City of Sugar Hill Planning Staff Report

CBD Design Review 20-00520

SUBJECT: Central Business District (CBD) Design Review

4888 Roosevelt Circle

PURPOSE OF THIS CONCEPT:

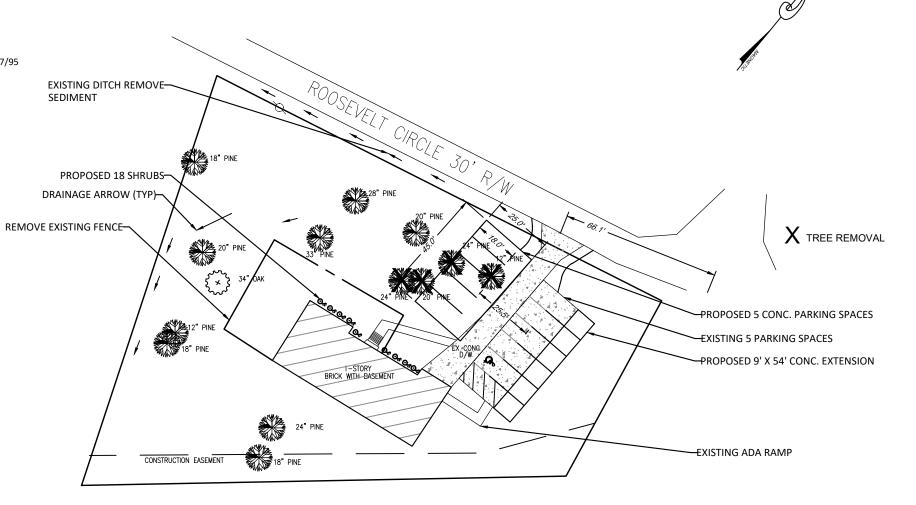
1. Is the proposed project consistent with the adopted design guidelines for the type of development, and/or the proposed use?

The CBD requirements are designed to foster development of the city center using traditional block patterns characterized by common side walls, building fronts abutting the sidewalk and onstreet parking; breaking up large blocks; optimizing multi-modal connectivity and incorporating small public gathering spaces.

The proposed design is consistent with the adopted design guidelines.

2. Is the proposed project consistent and compatible with the nature and character of the surrounding areas?

The proposed designs are consistent with the emerging nature of the area being developed under the Central Business District Overlay.

3. Are the site design, landscaping, general design, character, arrangement and scale of buildings, texture, materials and colors of the project similar to or compatible with features or structures in the area.

Yes. The applicant is proposing to clean up and repaint the existing buildings. The proposed improvements will enhance the visual appeal of the property and remain consistent with the surrounding businesses.

4. Will the interior arrangement or use have any effect on exterior architectural features and otherwise complies with the standards of this ordinance?

No adverse impacts.

5. Does the project contribute or resemble the following criteria for considering a design inappropriate?

Character foreign to the area / Arresting and spectacular effects / Violent contrasts of material or color, or intense or lurid colors / A multiplicity or incongruity of details resulting in a restless and disturbing appearance / The absence of unity and coherence in composition not in consonance with the density and character of the present structure or surrounding area.

No. The proposed changes do not contribute to any of the listed inappropriate design criteria.

Approval the design concept in material and architectural detail as shown on the attached Exhibits 1 and 2.
